HISTORIC LANDMARK COMMISSION

WESTERN GARDEN CENTER RENOVATION PLNHLC2010-00791 550 South 600 East May 5, 2011

Planning and Zoning Division
Department of Community and
Economic Development

Attachment A
Photos of Type of Roof Proposed

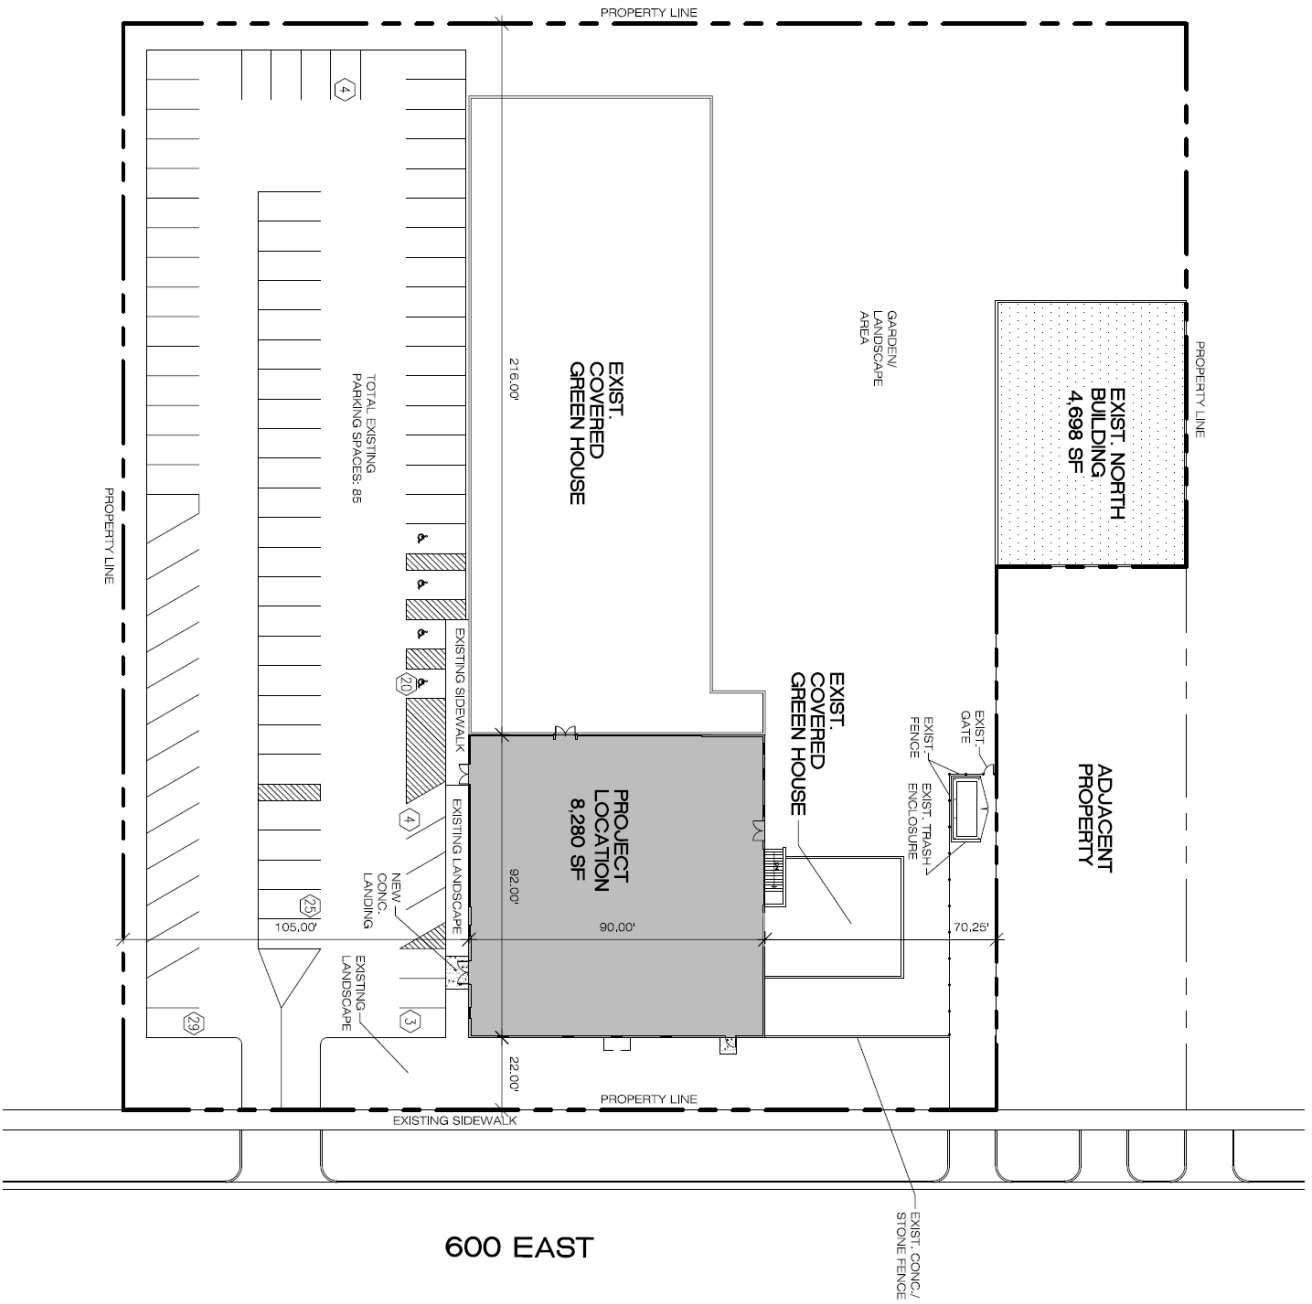
Analysis: The historic use of the property is commercial, and will continue to be commercial. Nonetheless, the use of the ceramic tile on the roof constitutes a significant change in the defining characteristics of the building, which in turn will have an effect on the overall character of the site and its environment. The building is a utilitarian commercial building from the early 1960's with aluminum trim, rock and glass features on the main building, and cement block construction on the front addition.

When approving the pitched roof on the front façade, the HLC found that the pitched roof is simple in its design, and that it is not out of character from the existing buildings in the immediate neighborhood. The use of a ceramic tile roof will alter the simplicity of the design, by making the roof the primary focus of the building when viewed from the street, thereby reducing the utilitarian commercial character of the original architecture.

Analysis: Although the ceramic tile roof would be located on an addition, its presence would impact the unique character of the property. The introduction of a ceramic tile roof on a building with two distinct architectural styles (cement block addition, glass, aluminum and rock original structure) will further diminish the character of the building by introducing yet another architectural style. Ceramic tile roofs are generally associated with southwestern, Tuscan, Spanish, or Provincial type architecture and are generally not found on 1960's style commercial buildings.

Analysis: The pitched roof is simple in its design. It is not out of character from the existing buildings in the immediate neighborhood but different enough that it will not recreate or replicate the existing history in the neighborhood. Nonetheless, the placement of a ceramic tile roof does alter the simplicity of the roof, and is not generally associated with buildings from its own time.

Analysis: The architectural features that characterize the building are located in the rear, away from the area where the work will be done. The proposed modifications will not alter or impact the more significant areas in the rear of the building. Even so, the issue lies in the fact that the ceramic tile roof will impact the distinctive features of the building and site by mixing styles, and materials that are not complimentary to the original architecture. As a result, the finishes, construction and general characteristics of the property will be diminished.

Analysis: As stated above, staff analysis indicates that the use of a ceramic tile roof on the pitched roof will have a negative effect on the architectural feel of the building as it relates to the original section as well as the surrounding vernacular.

Staff recommends that the Historic Landmark Commission review the proposed ceramic tile roof, and deny the request pursuant to the findings in this staff report.

Staff further finds that the use of an asphalt shingle roof on the building best preserves the character of the property.

The use of an asphalt shingle on the building is complimentary to the overall design, is a material that has been widely accepted and used throughout the city, and will be compatible with the immediate neighborhood.
